January 4, 1990

STAFF REPORT
(Final Plat)

CASE NUMBER: S/D 89-88 - KILLARNEY PLAZA FOURTH ADDITION

VICINITY MAP:

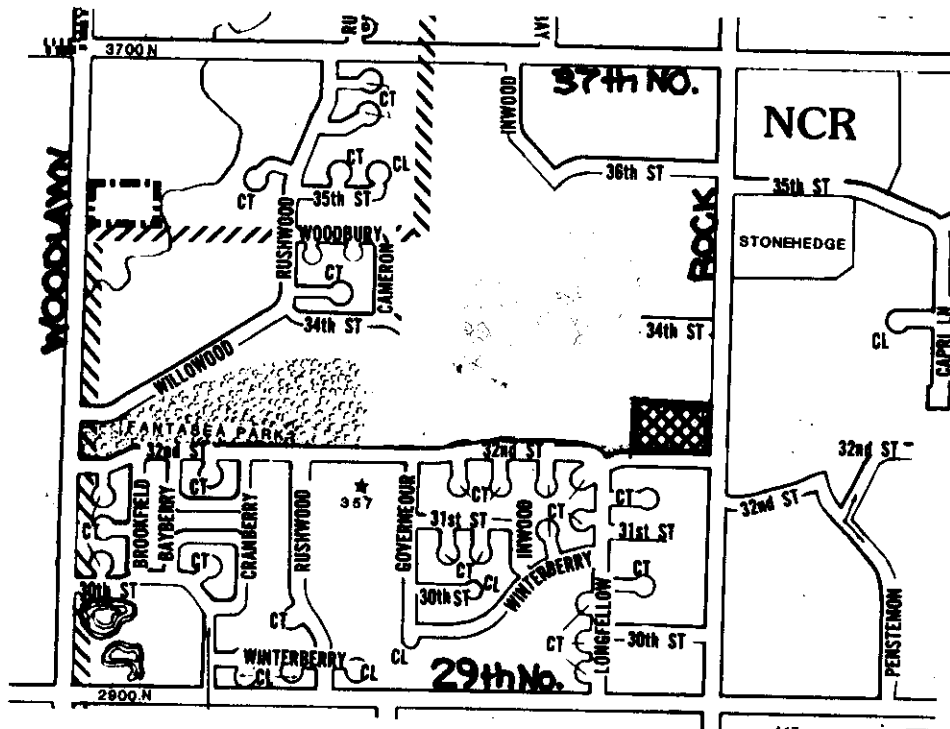
- E. The applicant proposes a joint access easement to provide Lot 1 with access to 32nd Street North across Lot 2. The proposed joint access easement will need to be established by separate instrument with appropriate recording information indicated on the final plat tracing. Prior to recording the joint access easement, a draft shall be submitted to the Planning Department for review and approval. The instrument must clearly state the purpose of the easement as well as which properties benefit from the easement. Initial construction responsibilities and future maintenance of the driveway within the easement should also be addressed by the text of the instrument.

- F. The associated CUP (DP-158) provides only one opening to this track to and from Rock Road. The platlor's text indicates Lot 2 is to have the one allowed opening. The final plat tracing shall indicate complete access control along the east line of Lot 3 and make the appropriate reference in the platlor's text.
